**1958 Agreement – Consideration of draft amendments
to existing Regulations submitted by GRSP**

Proposal for Supplement 9 to the 04 series of amendments to Regulation No. 44 (Child Restraint Systems)

Submitted by the Working Party on Passive Safety *

Figure 1a

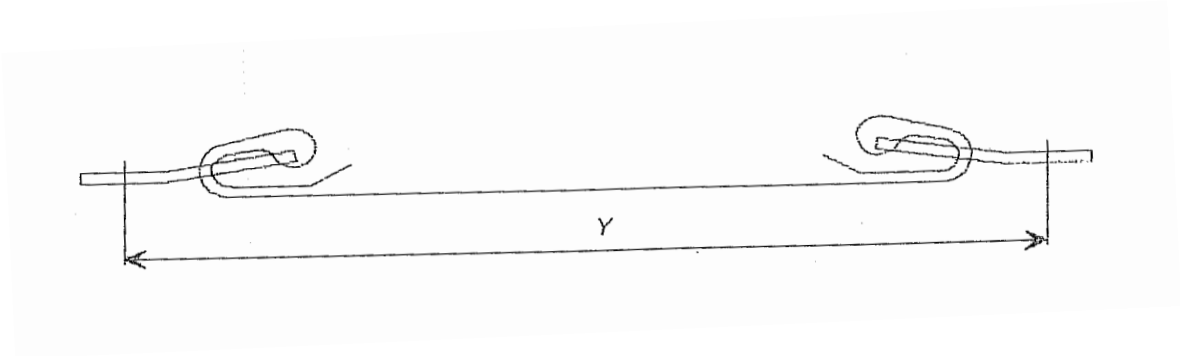
Figure 1, amend to read:

"Figures 1a and 1b

Standard seat belt configurations

"5. The two-point static belt as shown in Figure 1a consist of ...

6. ...The value of Y in Figure 1a is ..."
